TECHNICAL MEMORANDUM

PEER REVIEW OF SACRAMENTO VALLEY FINITE ELEMENT GROUNDWATER MODEL (SACFEM)

U.S. Bureau of Reclamation

October 2011

Figure 35. Transient Calibration Hydrograph for Well 12
 (Layer 1) – Central Sacramento County, North of American River
 (Blue markers and grey line represent observed and simulated groundwater elevations, respectively)

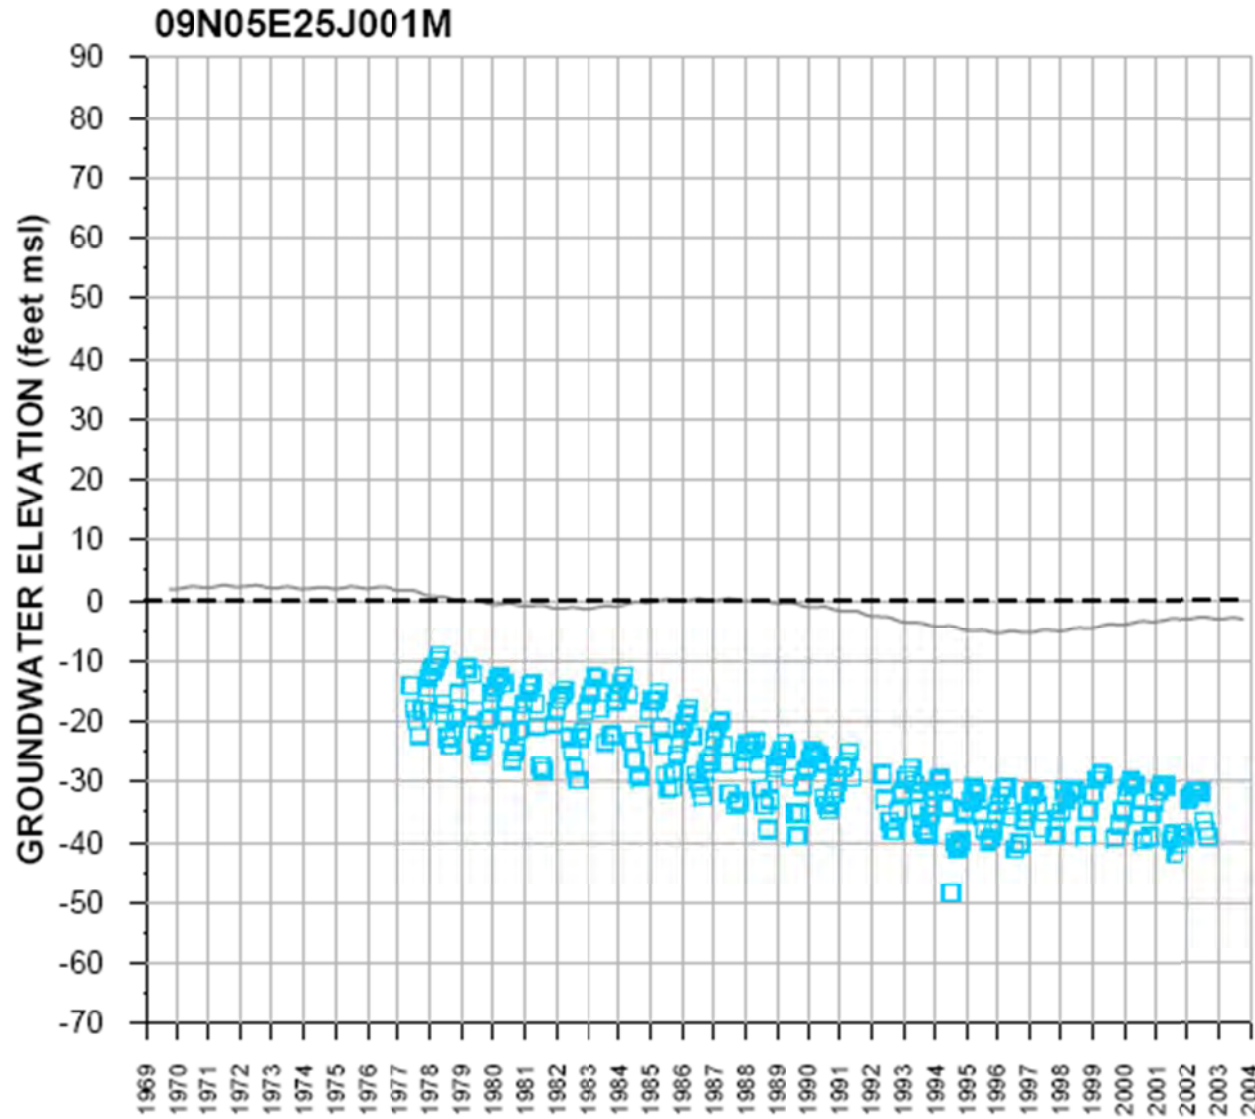
The long-term trend of observed groundwater elevations is not matched by Well 12 (Figure 35). Simulated groundwater elevations are approximately 40 feet higher than the observed values. This well is in the urban area of Sacramento. High streambed resistances are used for the nearby American River. Approximately 80,000 acre-feet of urban groundwater pumping in this area is not included in SacFEM. As a result groundwater levels are significantly higher than the observed values.

Figure 37. Proposed Calibration Wells

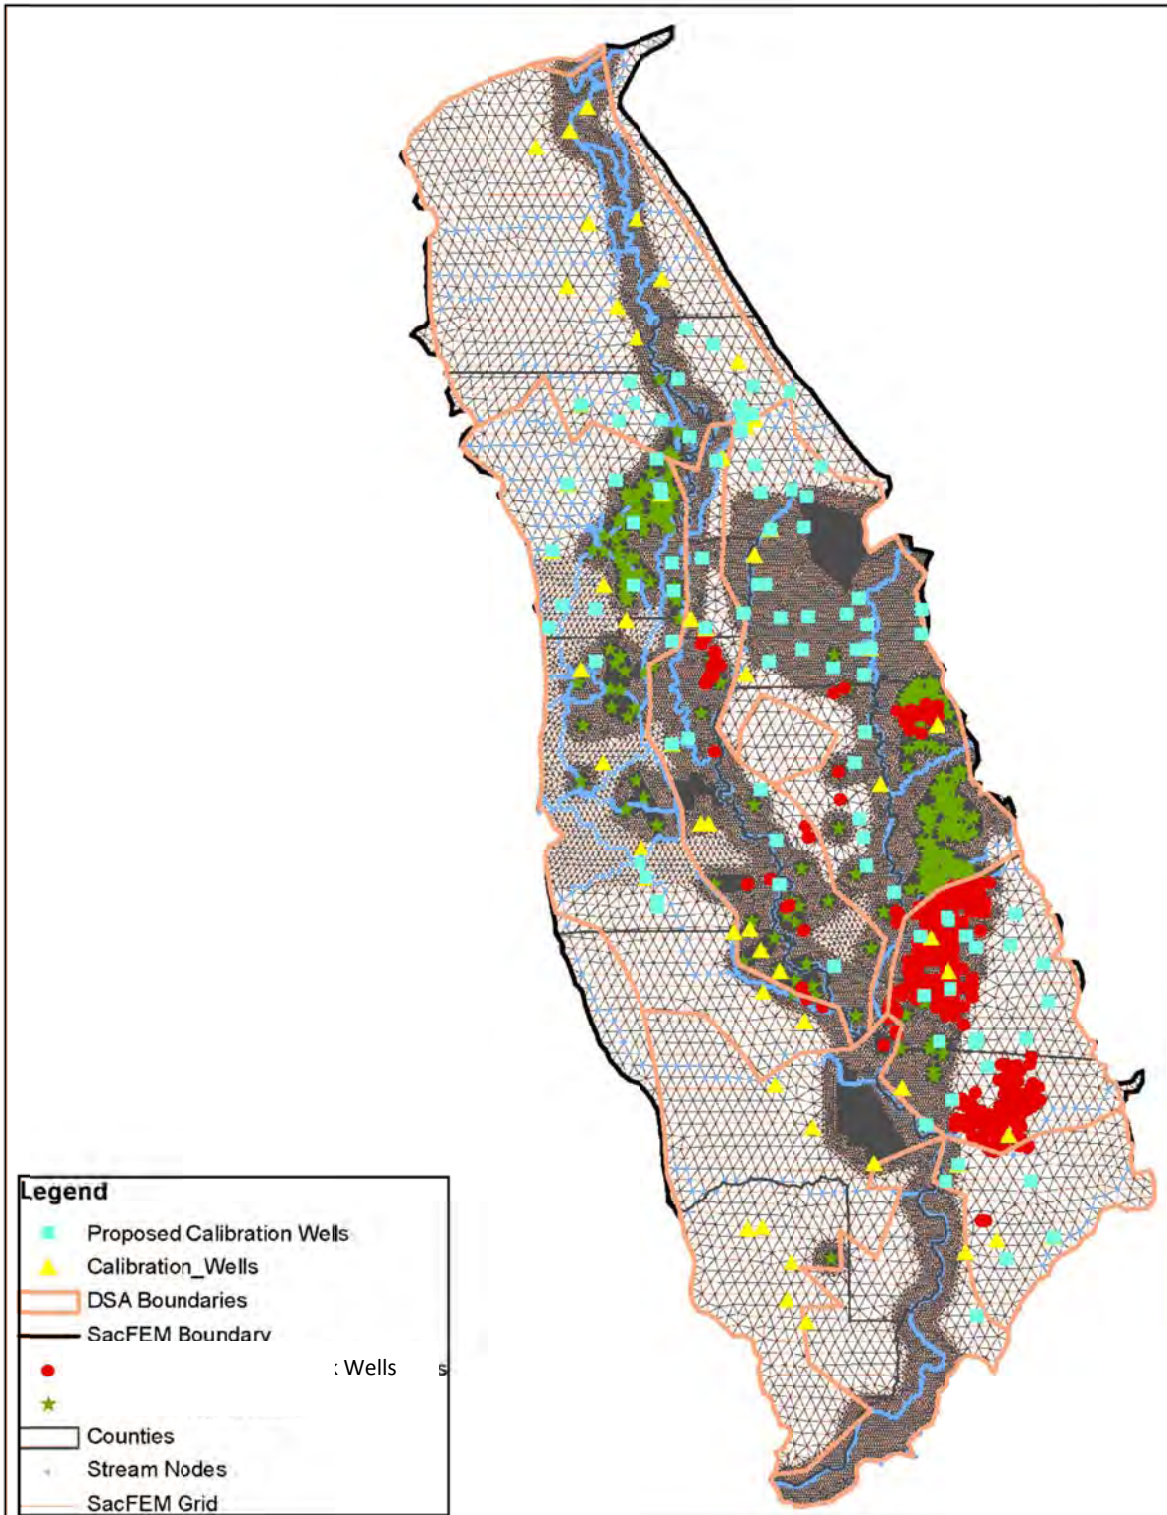
Groundwater elevation of these wells was reviewed and a set of 108 wells was selected, which could be added to the SacFEM calibration wells to improve the calibration quality of the model in western Placer, southern Sutter and Yuba Counties (Figure 37). These areas are of special interest as a significant number of SVWMP and 2009 Drought Water Bank projects wells are located in this area.

It is recommended to include additional calibration wells in SacFEM to improve its calibration quality. These wells could be used for re-calibration of SacFEM with a focus on the fine grid areas and areas with significant stream-aquifer interactions.
